Project	<b>IEEE 802.16 Broadband Wireless Access Working Group</b> < <a href="http://ieee802.org/16">http://ieee802.org/16</a> >
Title	<b>Secure Extended MAC Header Type II</b>
Date Submitted	<b>2007-<del>03-28</del>05-04</b>
Source(s)	Shashikant Maheshwari, Yousuf Saifullah, Yogesh Swami, Haihong Zheng, Adrian Boariu Nokia Siemens Networks 6000 Connection Drive, Irving, TX voice: 972 839 1878 mailto: <a href="mailto:shashikant.maheshwari@nsn.com">shashikant.maheshwari@nsn.com</a>
Re:	IEEE 802.16j-07/013:“Call for Technical comments and contributions regarding IEEE Project P802.16j”
Abstract	This document presents a mechanism for securing Extended MAC Header Type II.
Purpose	Propose an efficient signaling acknowledgment operations for IEEE 802.16j
Notice	This document has been prepared to assist IEEE 802.16. It is offered as a basis for discussion and is not binding on the contributing individual(s) or organization(s). The material in this document is subject to change in form and content after further study. The contributor(s) reserve(s) the right to add, amend or withdraw material contained herein.

## Secure Extended MAC Header Type II

Figure XX Extended MAC Signaling Header Type II Format

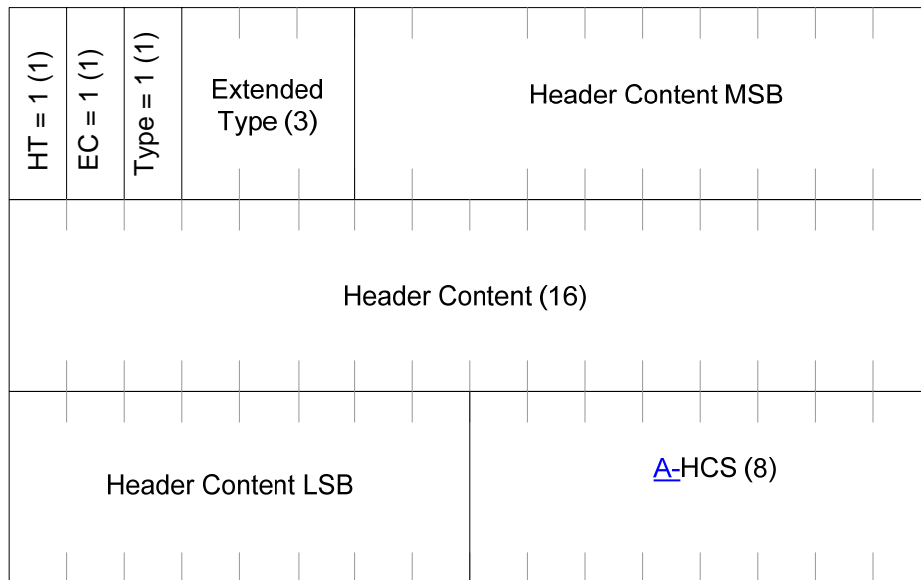
[Change only the HCS field in Figure XX to A-HCS:]

This type of MAC header has 8-bit mandatory Authenticated Header Check Sum (A-HCS) field for providing error and integrity protection. A-HCS is computed using the message authentication code as mentioned below:

$$A-HCS = CMAC( CMAC KEY U \otimes counter, 5\text{-byte-checksum}) \bmod (D^8 + D^2 + D + 1)$$

$$A-HCS = HMAC( HMAC KEY U \otimes counter, 5\text{-byte-checksum}) \bmod (D^8 + D^2 + D + 1)$$

Where CMAC/HMAC KEY U is the CMAC/HMAC key that the RS has generated during key exchange and counter is a monotonically increasing number, which is of the same bit-length of CMAC/HMAC KEY U and  $\otimes$  indicates the XOR operation.
